Correspondence

Re: Town of Brunswick
**Brunswick Meadows - Planned Development District
FEIS Completeness Review
Responses & Supplemental Information**
Rensselaer County, State of New York

In response to your October 5, 2007 Memorandum to J.P.J. Partnership regarding the above referenced project, please find the following supplemental information and responses that addresses all of the comments in said Memorandum:

Town of Brunswick Zoning Map

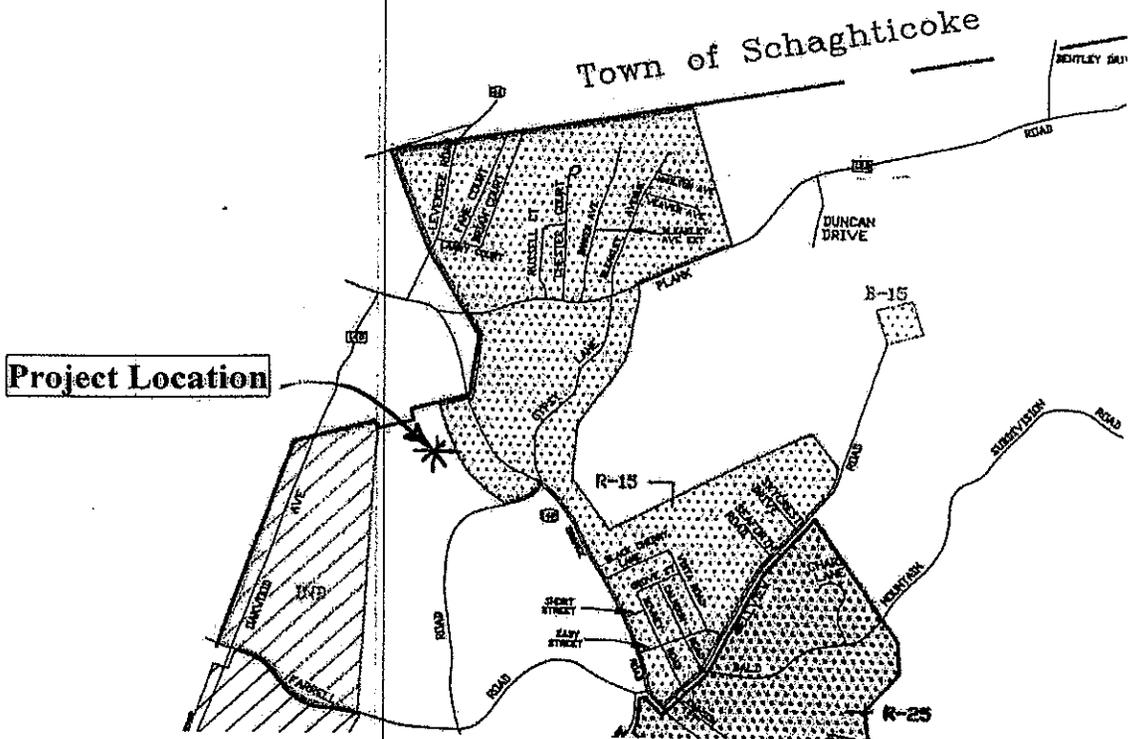
4. Several comments were received during the public hearings and written comment period concerning proximity of proposed condominium buildings to existing residences on Grange Road and the overall density of the project in relation to green space on the project site. The FEIS should examine an alternative layout, which promotes green space towards the front of the project site adjacent to Grange Road and in proximity to existing residences on Grange Road. Further, the FEIS should include an expanded discussion of density of units on this project site in relation to permitted density in current zone classifications for the project site.

Furthermore, the existing adjacent lots along NYS Route 142 from the Town Line to Liberty Road and across NYS Route 142 to Plank Road and beyond to the Town Line with the Town of Schaghticoke include this same R-15 zoning. This zoning allows for lots that are approximately 1/3 of an acre in size. See attached portion of the Town of Brunswick Zoning Map.

The existing parcel for the Brunswick Meadows project (18.3 acres) is divided into two zoning districts, R-15 (residential) and A-40 Agricultural. The R-15 zone extends 500' from Route 142 and allows for 15,000 square feet (sf) lots with 35' front, 15' side and 35' rear setbacks required. These units could be situated within 15' to 35' of adjacent owners' current property lines.

The current site contains approximately 6.5 acres within the R-15 zone. A maximum build out of the 6.5 acres could result in 18 lots ($6.5 \times 43,560 \text{ sf} = 283,140 \text{ sf} / 15,000 \text{ sf} = 18.8$ units) of housing. The remaining 11.8 acres are currently zoned A-40. The A-40 zoning has a minimum lot size of 40,000 sf or less than an acre. The maximum build-out of the remaining A-40 zone is 12 building lots ($11.8 \times 43,560 \text{ sf} = 514,008 \text{ sf} / 40,000 \text{ sf} / \text{lot} = 12.8$ units). Therefore, the existing parcel as currently zoned allows for 30 building lots.

DRAWING TITLE:
ARCHEOLOGIC AVOIDANCE PLAN

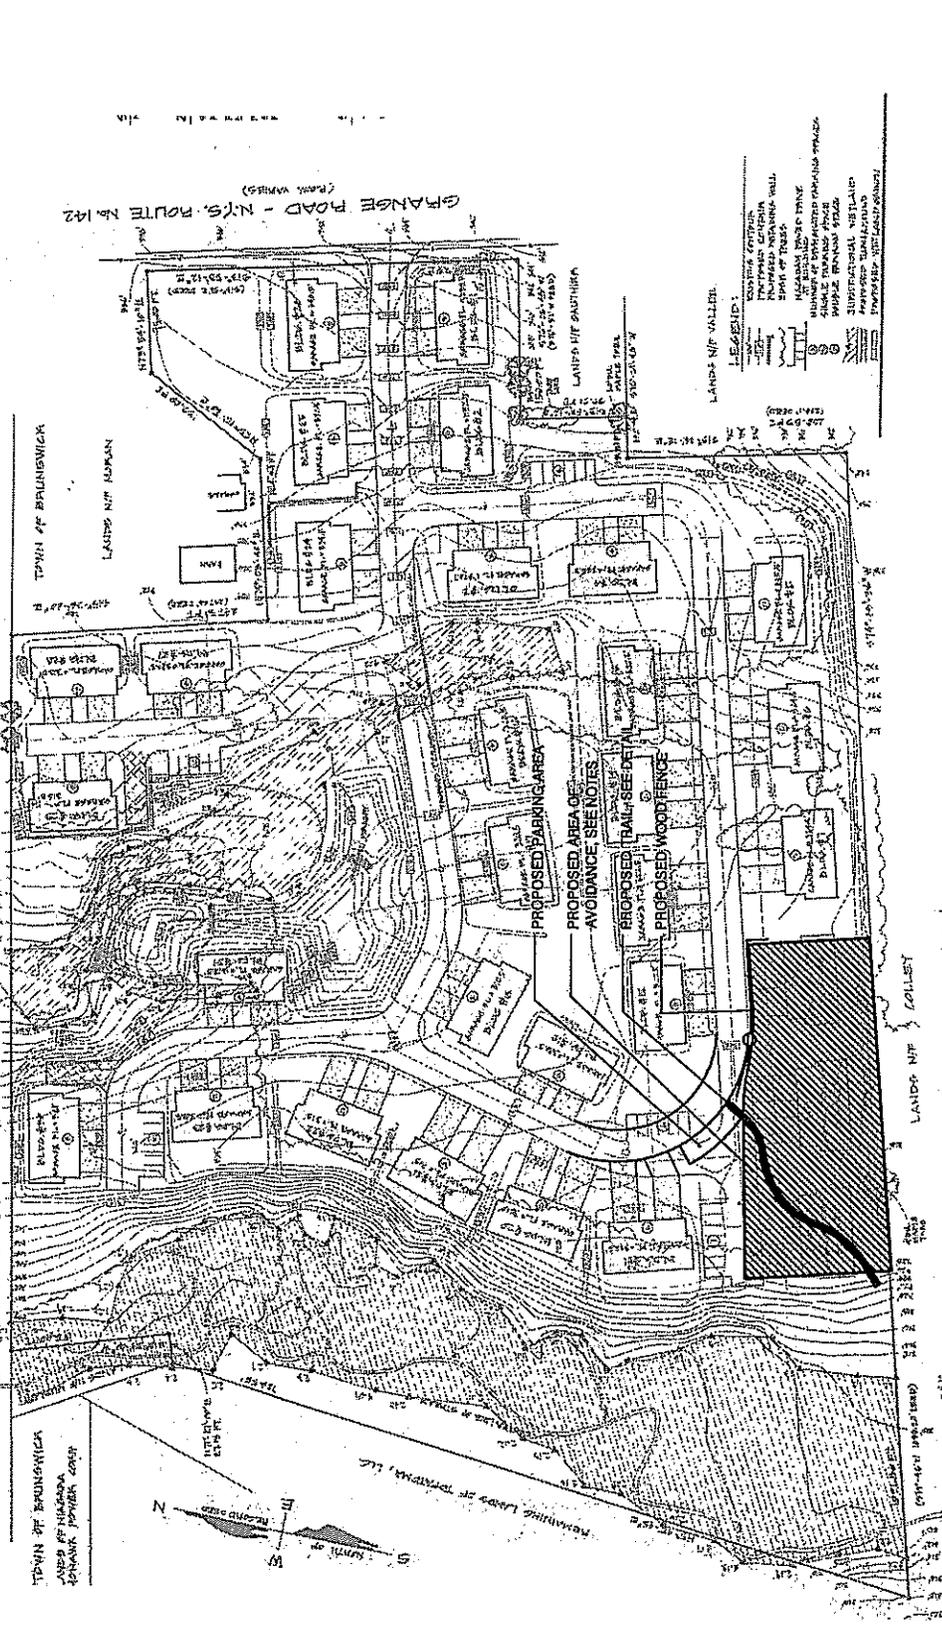
8. Please provide large-scale project plans that incorporate the archeological avoidance plan.

The *Brunswick Meadows Precontact Site (A08302.000229)* should be identified on the site plan with the site boundary in addition to having the buffer boundary. The OPRHP recommends avoidance of the site or a complete Phase II. An Avoidance Plan will need to be submitted which includes provisions for a covenant with the deed (see enclosure).

Revised map has been completed and will be sent from Erdman Anthony Associates under separate cover to Mark Kestner, PE.

- NOTES:
1. FINAL CONSTRUCTION DRAWINGS SHALL CLEARLY DELINEATE AVOIDANCE AREA AS A SENSITIVE AREA / NO ACCESS
 2. DURING CONSTRUCTION, AVOIDANCE AREA SHALL BE PROTECTED WITH A TEMPORARY FENCE WITH SIGNAGE STATING "SENSITIVE AREA / NO ACCESS"

3. A PRE CONSTRUCTION MEETING WITH THE CONSTRUCTION CONTRACTOR(S) IS REQUIRED TO NOTIFY THOSE IN CHARGE OF THE REQUIREMENTS TO AVOID/PROTECT THE SITE.
